S.A. 31T2-6

Subject: Avionics Bay Door Seal and Protective Blanket Installation

Model Affected: PA-31T2 Cheyenne II XL

Serial Numbers Affected: 31T-8166001 through 31T-8166012

SKETCH I

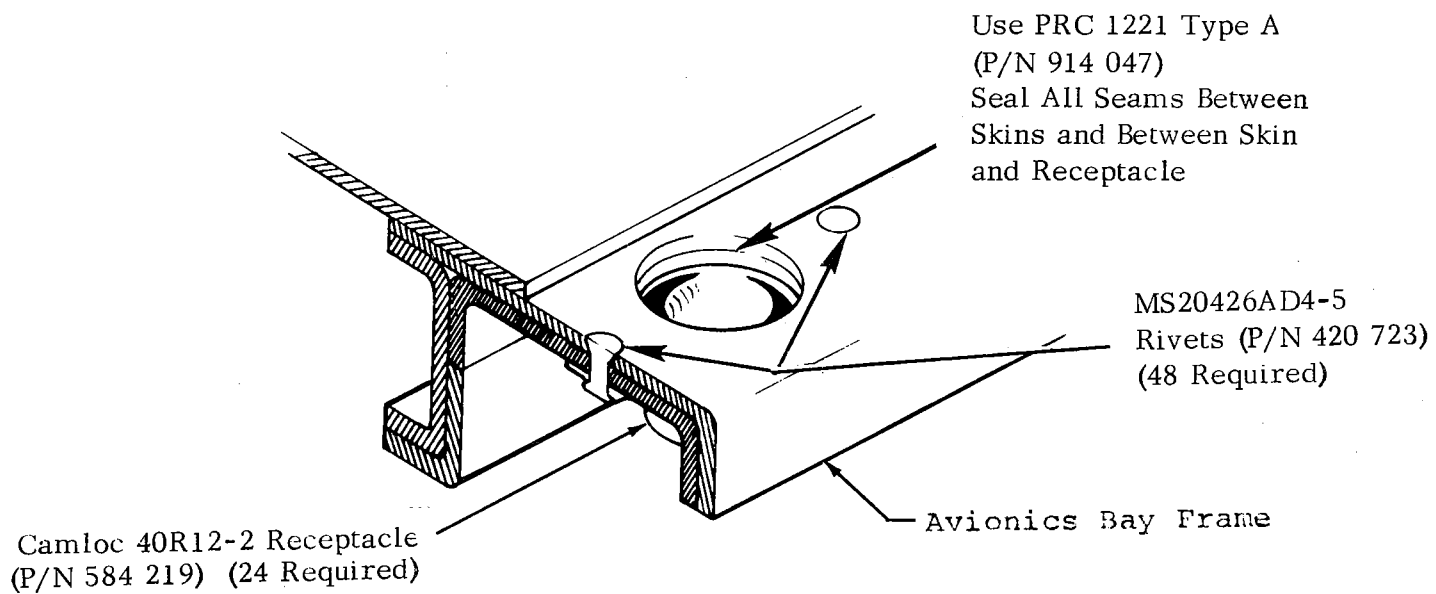
1. Replace the twenty-four (24) Camloc receptacles on the avionics bay door frame with closed type receptacles as follows:
 - a. Drill out the two (2) rivets attaching each of the receptacles to the door frame, and remove the receptacles (Sketch I).
 - b. Attach twenty-four (24) new closed type 40R12-2 Camloc receptacles (Piper Part No. 584 219) at each existing receptacle cutout. Use two (2) MS20426AD4-5 rivets (Piper Part No. 420 723) at each receptacle. Seal as shown (Sketch II).
2. Install protective blanket (Piper Part No. 01312-03) as follows (Refer to Sketch III).
 - a. Install the hook portion (180 410) of Velcro Tape in the corner of the door frame. Use Carboline neoprene F1 Adhesive or equivalent (Contact cement).
 - b. Install blanket (01312-03) as shown, using 6-inch segments of trim strip (189 379).
3. Make appropriate logbook entry of compliance with this Service Release.
